- 1. Clam Gulch Heights 2022 Addition; KPB File 2022-136
Johnson Surveying / Wann Family Trust, Ciccone
Location: Ciccone Street & Russel Avenue
Clam Gulch Area**

Clam Gulch Heights 2022 Addition Preliminary Plat

ITEM 1 – CLAM GULCH HEIGHTS 2022 ADDITION

STAFF REPORT

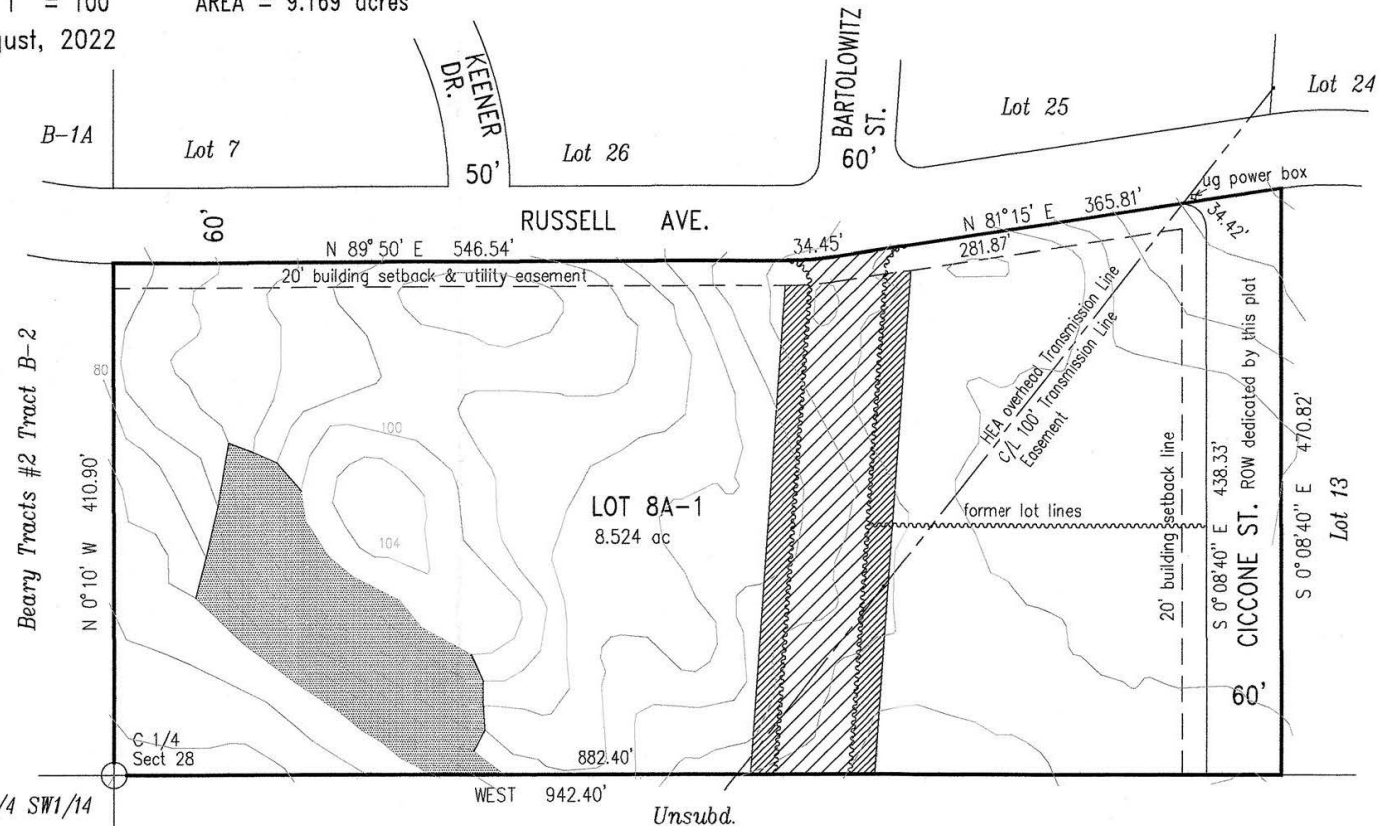
Street includes the utility easements as shown on the plat. The plat will have a 20 foot utility easement along Russell Avenue within the former right-of-way. The plat does not indicate the utility easement intention along the new dedication. Code only requires 10 foot utility easement. **Staff recommends the easement along the western boundary be depicted and labeled as being granted by Plat KN 72-61, the 20 foot utility easement along Russell Avenue be labeled as being granted by Plat KN 81-135, note that the transmission easement was granted by Plat KN 72-61, and either add to the description along the new dedication "and utility easement granted by this plat" or depict a 10 foot utility easement with a label "granted by this plat".**

The plat was submitted to the utility providers for comment. Homer Electric Association noted that there is an existing overhead line within the southwest corner of the subdivision and requested a 30 foot easement centered on existing line including guy anchors. **Staff recommends the line be located and depicted with the easement being granted as requested and noted that it is "granted by this plat."**

ACS stated they did not approve of the proposed vacation of utility easements adjacent to the dedication as they currently have equipment within that area. They stated they can be moved but at the owner's expense. **Staff recommends the owner works with ACS for a resolution that could include leaving the utility easement, granting of new easements, or relocation of equipment and written confirmation from ACS must be submitted that they agree prior to finalization of the plat.**

- Staff recommendation:** In the first line of description, add a space between 12 and 13. Remove "17, 18 (KRD 81-135)" from the third line.
- D. A vicinity map, drawn to scale showing location of proposed subdivision, north arrow if different from plat orientation, township and range, section lines, roads, political boundaries, and prominent natural and manmade features, such as shorelines or streams;

- Staff recommendation:** Update C.G. Road to spell out the road or use a leader. Staff could not find confirmation of Russell Lake.
- G. The status of adjacent lands within 100 feet of the proposed subdivision boundary or the land status across from any dedicated rights-of-way that adjoin the propose subdivision boundary, including names of subdivisions, lot lines, block numbers, lot numbers, rights-of-way; or an indication that the adjacent land is not subdivided;

- Staff recommendation:** Update the labels for the lot to the west.

Within plat note 1, correct the parent plat number.

Within plat note 2, correct the spelling of utility.
